CITY OF ALBUQUERQUE

RE: Wecks Restaurant – 7301 Paseo Del Norte Blvd NE
Conceptual Grading and Drainage Plan
Engineer's Stamp Date: 05/11/18
Hydrology File: C19D008

DRAINAGE AND TRANSPORTATION INFORMATION SHEET (REV 3/2018)

PROJECT TITLE		WECK'S RESTAURANT 7301 PASEO DEL NORTE NE ALEBUQUERQUE, NEW MEXICO 87113	
PROJECT MANAGER	JEFF WOOTEN	JOB NO.	2016024
DRAWN BY:		JEFF WOOTEN	
SHEET TITLE		Grading Plan	
DATE	05.11.2018	sheet-	C201
SCALE	PER PLAN	of	6

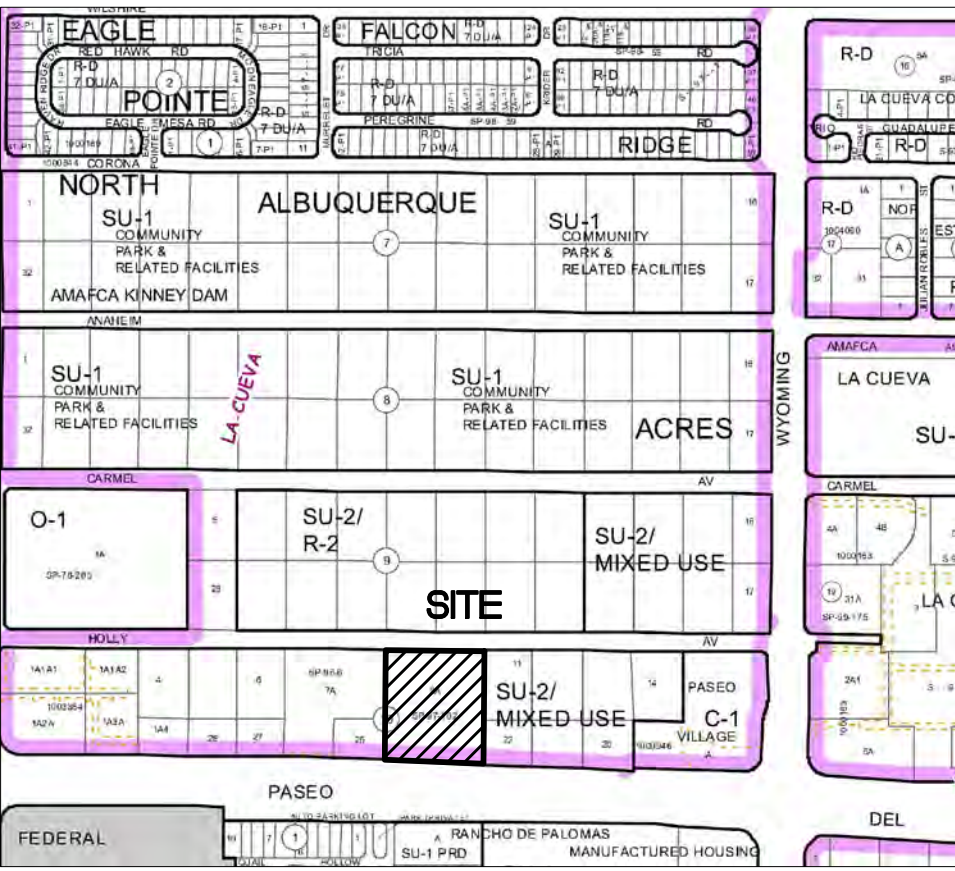
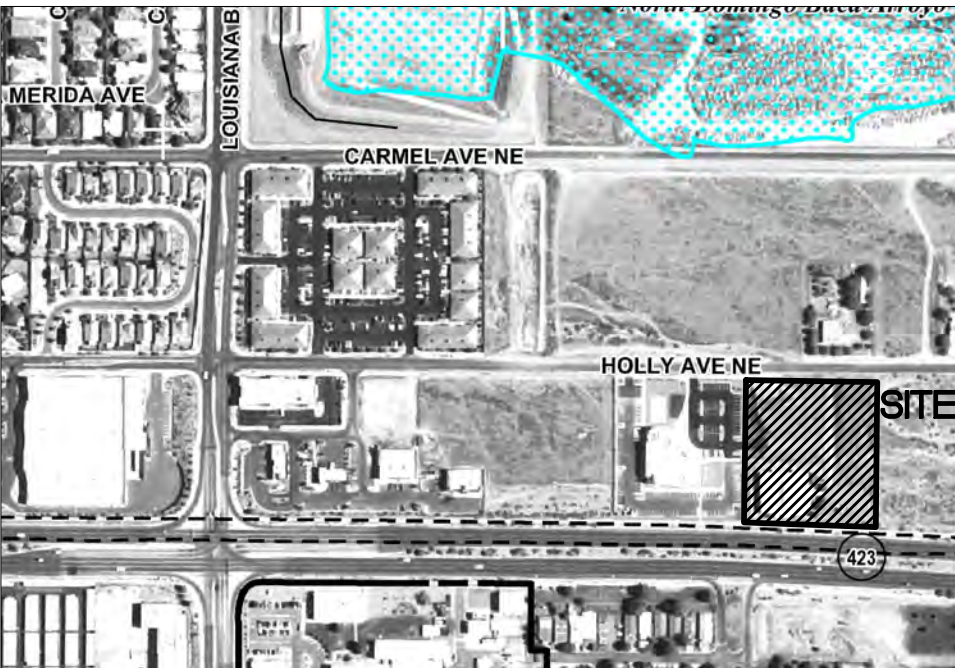
Based upon the information provided in your submittal received 05/15/2018, the Conceptual Grading and Drainage Plan is approved for action by the DRB on the Site Plan for Building Permit.

As a reminder, please provide a Private Facility Drainage Covenant per Chapter 17 of the DPM for the first flush ponds and the retention ponds prior to Certificate of Occupancy.
